Re: 19 Menelik Road – Daylight & Sunlight

Eb7 have been instructed to review and advise on the adequacy of the daylight and sunlight report submitted alongside the planning application (ref: 2025/0316/P) for the development at 19 Menelik Road, London NW2 3RJ.

3) Potential VSC effect to ground floor windows at 34 Somali Road not assessed

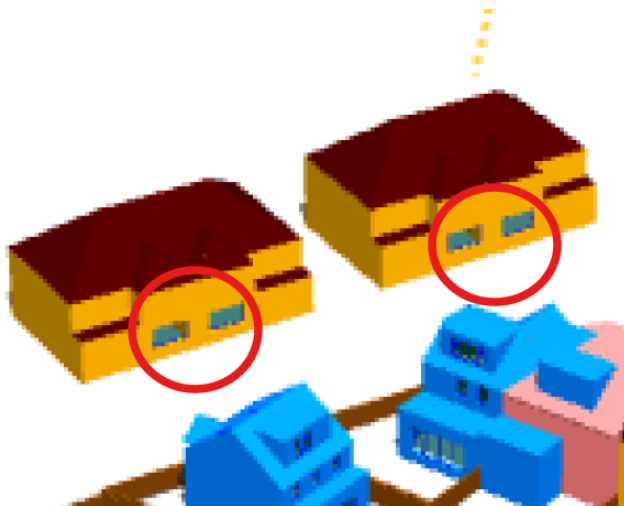
In addition to the 1st floor windows, the daylight and sunlight report also fails to assess the potential VSC impact to a ground window at 34 Somali Road that adjoins the south eastern boundary, as well as the ground floor glazed door serving the single storey rear extension to the same property.

These windows are either situated alongside a projecting element or beneath an eave overhang, both of these design factors can limit sky visibility and can make windows somewhat sensitive to changes in daylight. As such, we recommend that the VSC assessment is updated and the NSC study is undertaken to these areas to ensure that the potential impact on daylight to this property as a result of the proposed development is appropriately considered.

5) Misrepresentation of Full-Height Window at 21 Menelik Road

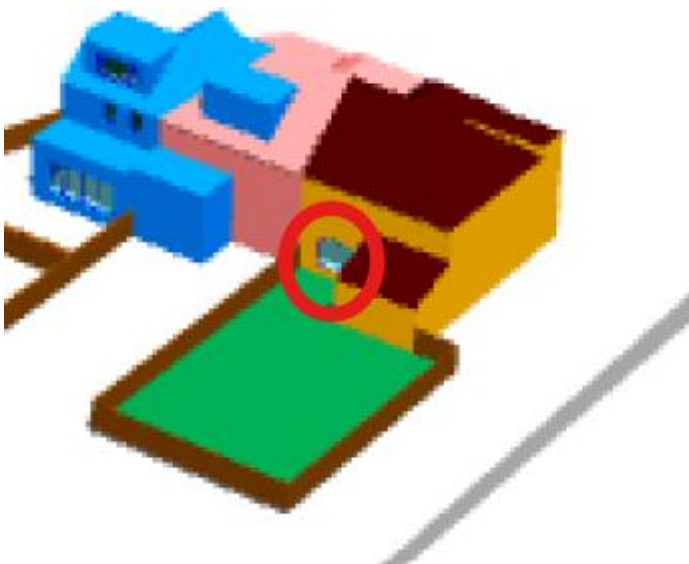
The report shows that a ground floor rear elevation window (labelled as 'W01') at 21 Menelik Road has been modelled with a sill, whereas the aerial photo in Appendix B illustrate that this particular window is a full height aperture in reality.

This discrepancy may lead to incorrect results in the Vertical Sky Component (VSC) analysis, affecting the accuracy of the conclusions drawn whilst questioning the reliability of the report. The modelling of windows should align precisely with the existing conditions to ensure a reliable assessment. This is particularly the case as the VSC test measures sky visibility from the centre point of each window and therefore this would be at a lower level for a full height window. On this basis, we request that all window sizes are amended and the VSC assessment is updated accurately to demonstrate that the potential effect on windows has been assessed appropriately.

7) **Use of a Transient Shadow Diagram Instead of the 2-Hour Sunlight Amenity Test**

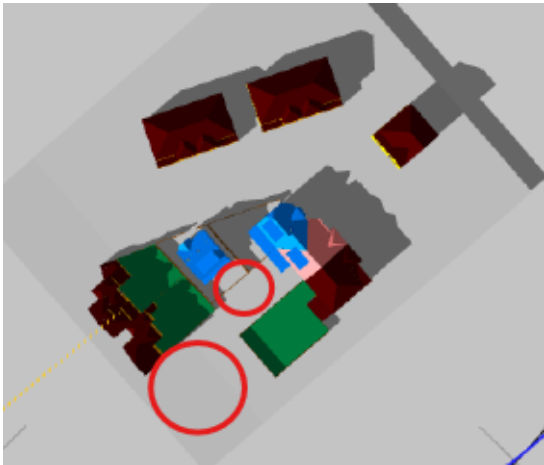
The report includes transient shadow diagrams (as shown in the image below) rather than drawings of the required 2-hour sunlight amenity assessment, as outlined in BRE guidance. The correct test assesses whether at least 50% of key amenity areas receive a minimum of 2 hours of direct sunlight on March 21st.

In the absence of drawings illustrating this analysis, there is no clear evidence that sunlight availability to the neighbouring outdoor spaces has been properly considered. Illustrations of the BRE recommended 2-hour sunlight amenity assessment should be provided. This should demonstrate an accurate representation of the local context taking into account existing shade from trees and the building obstructions.
